# Regional Review Finding

**RE:** Development of Regional Impact (DRI) Review

**Name of Proposal:** 981 Howell Mill Road Mixed Use Development DRI 4367

DRI SITE PLAN

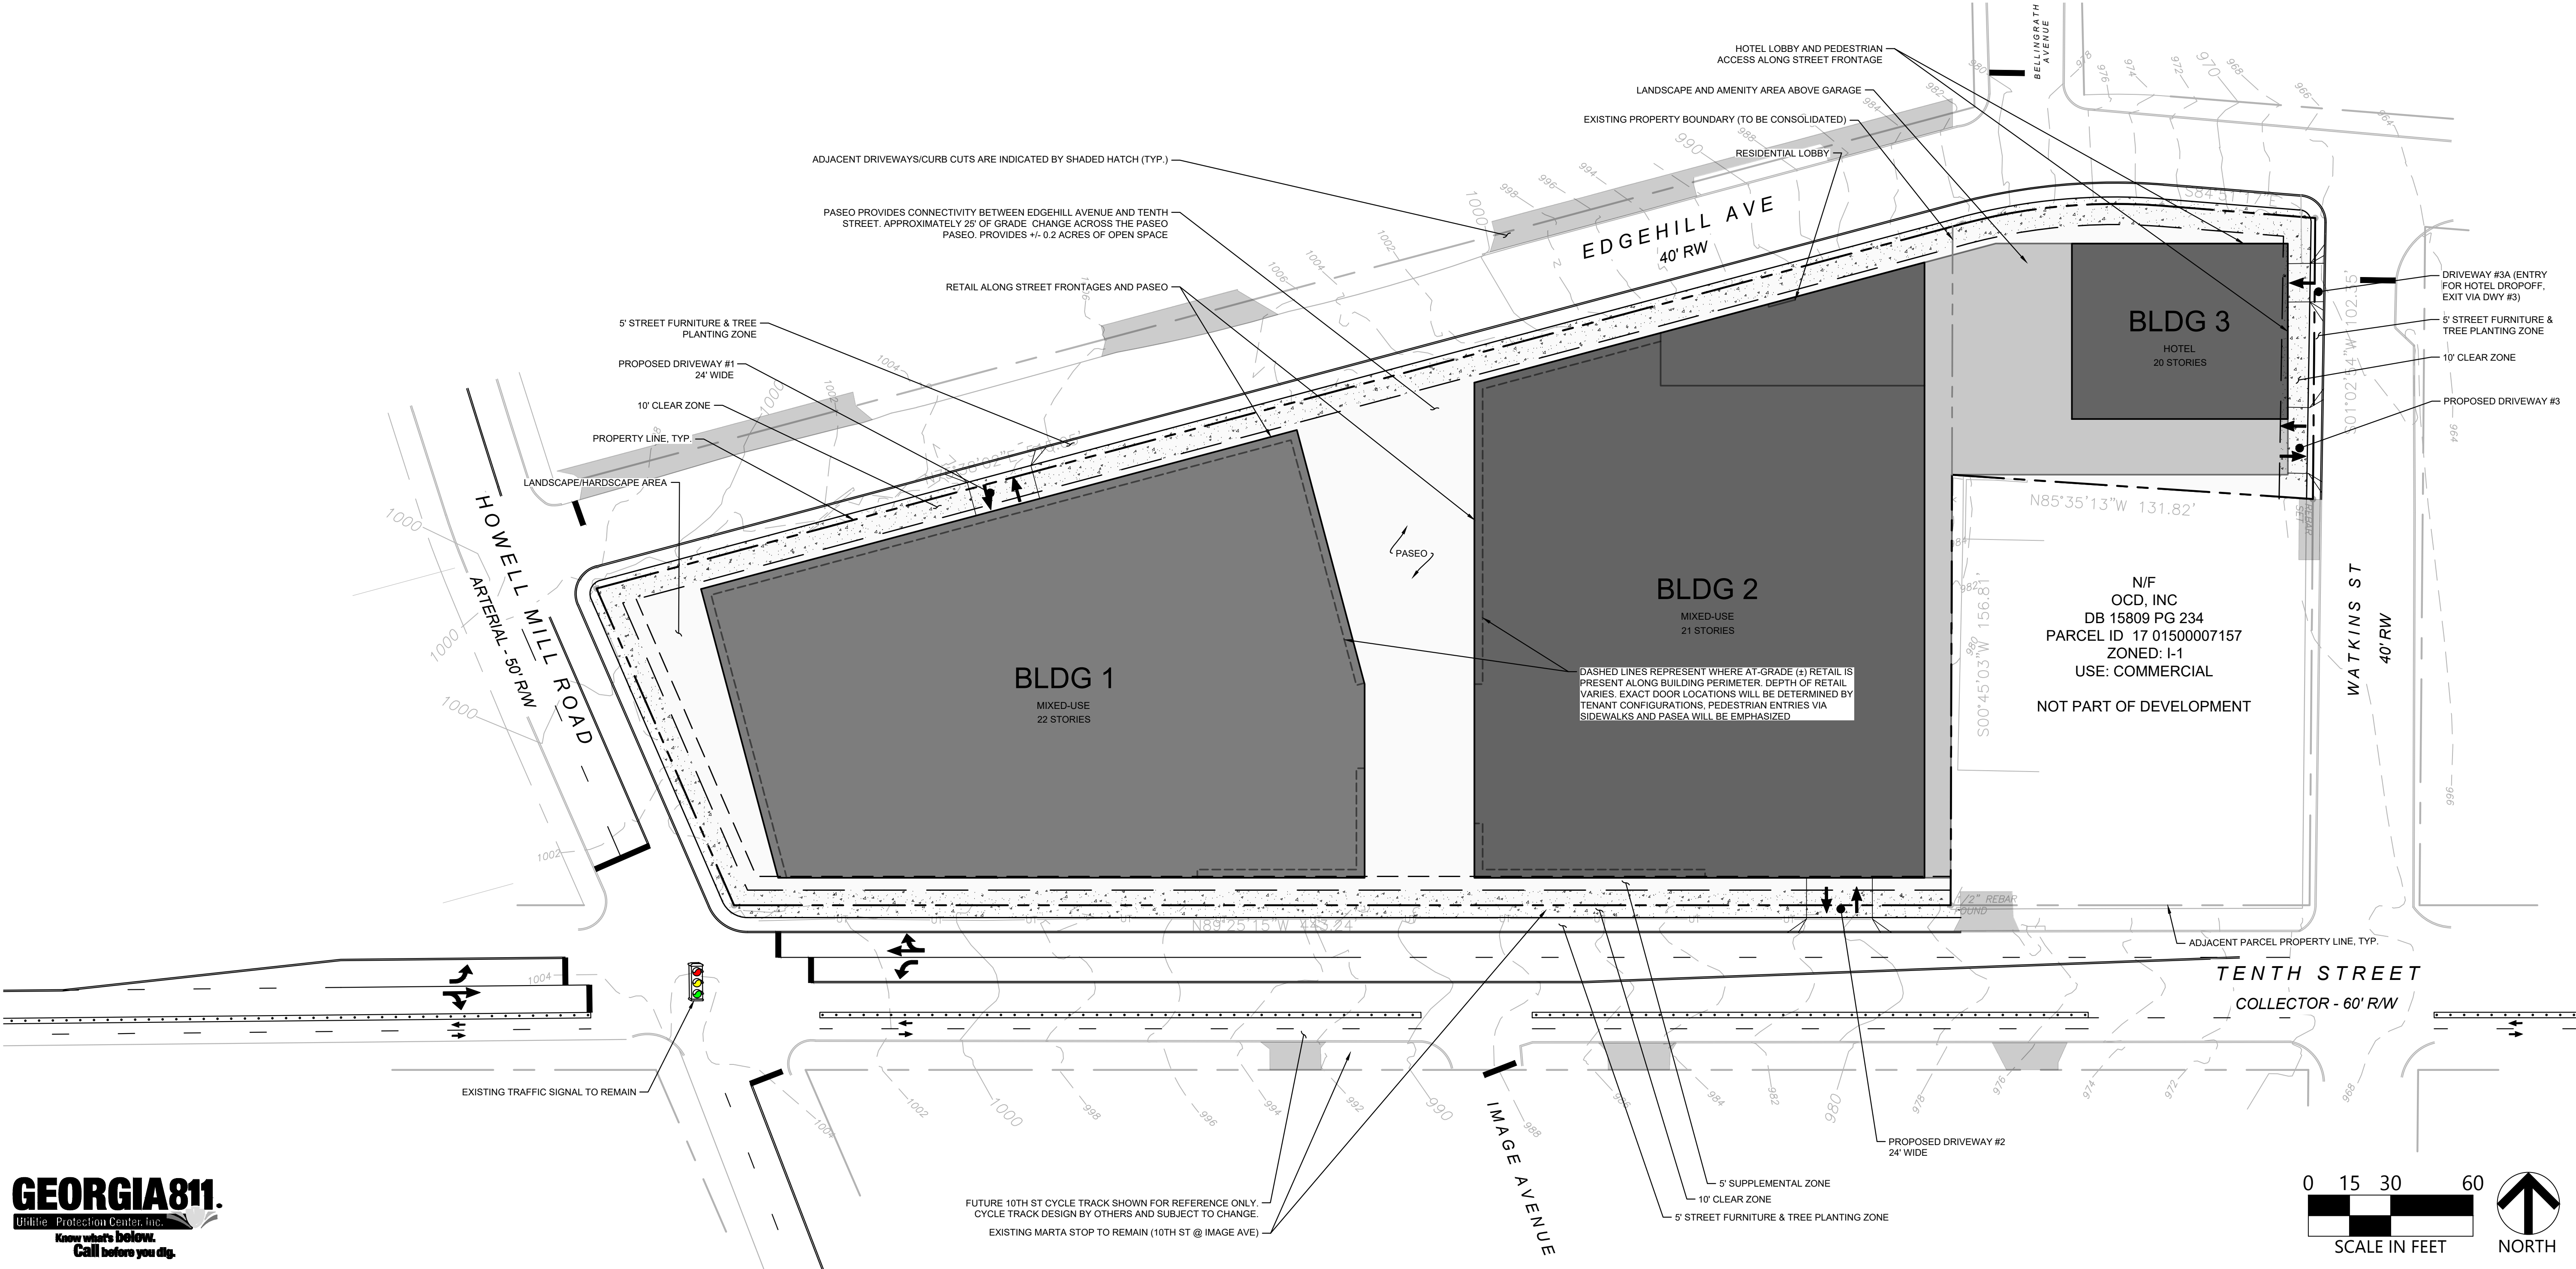
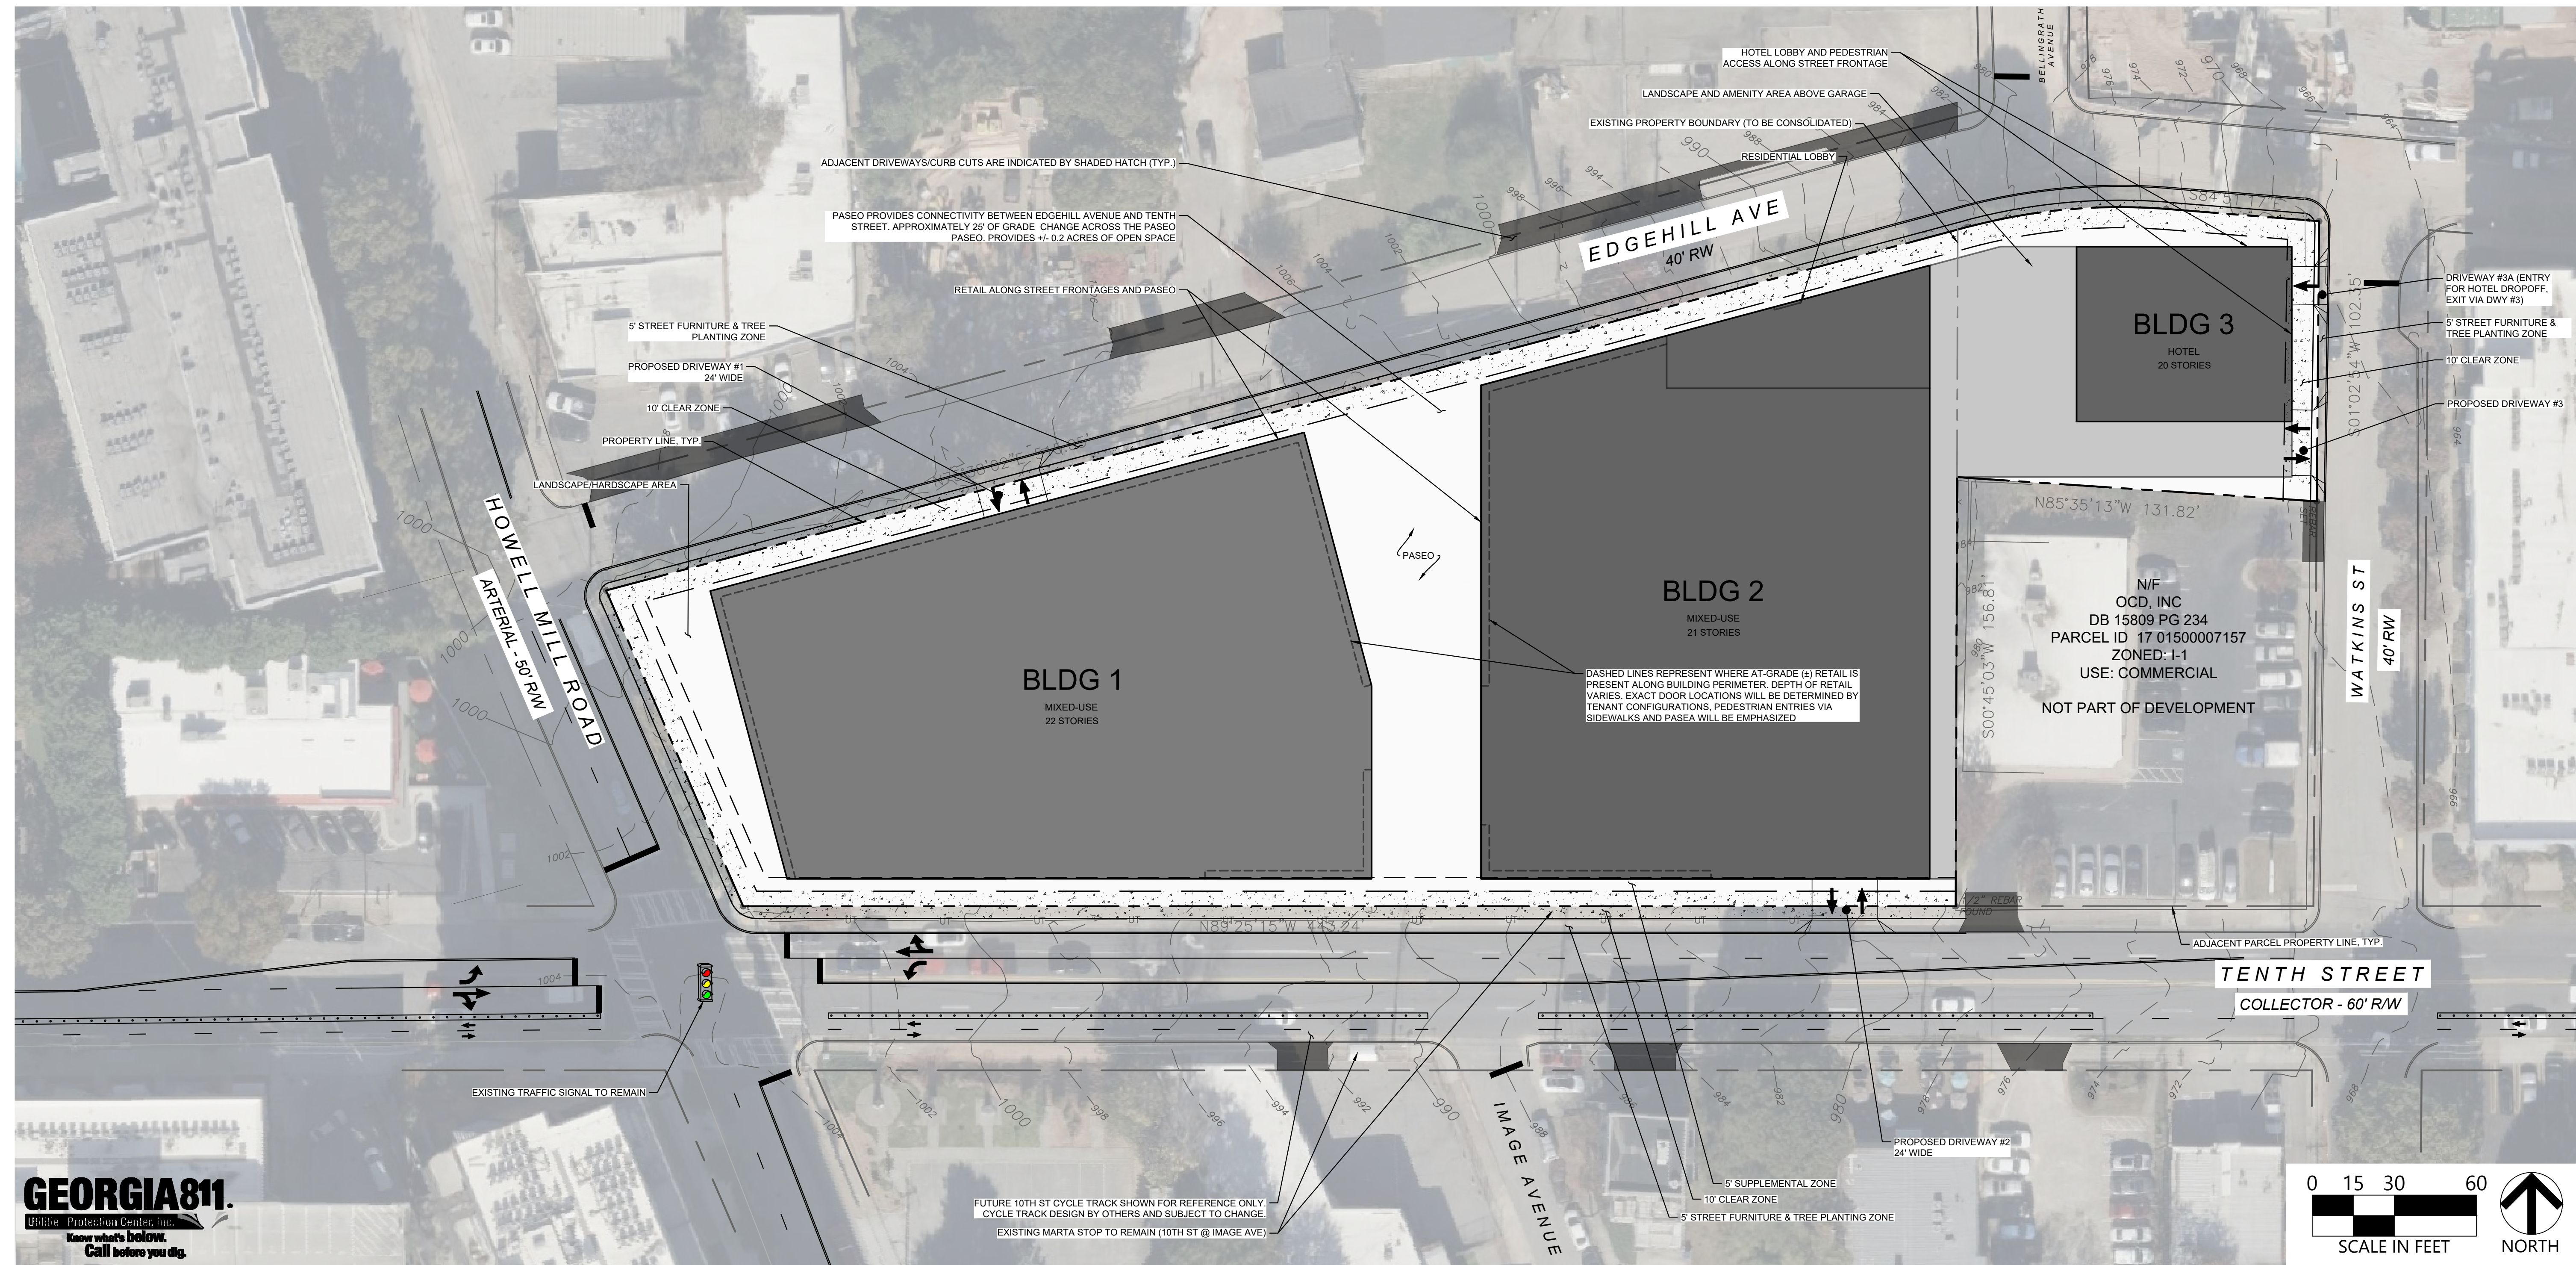
The USGS coverage for the project area shows no streams on or near the property. No streams or other waters of the State are shown on the submitted site plan and no evidence of streams or other waters is visible in available aerial photo coverage. Any unmapped streams identified on the property may be subject to the City of Atlanta's stream buffer ordinance. Any unmapped State waters identified on the property will be subject to the State 25-foot Sediment and Erosion Control buffer.

**1. Does the site plan provide for the construction of publicly accessible local road or drive aisle connections, or bike/pedestrian connections, with adjacent parcels?**

Connections are not made with adjacent parcels, but these connections may not be feasible due to private property concerns. The proposed development should further explore these possible connections.

**2. Does the site plan enable pedestrians and bicyclists to move between destinations within the development site safely and conveniently?**

The site allows for pedestrian movements within the development via sidewalks and paseo. Bike connections are not directly accounted for but are not feasible within site. Bike improvements along surrounding streets will improve bicycle access.
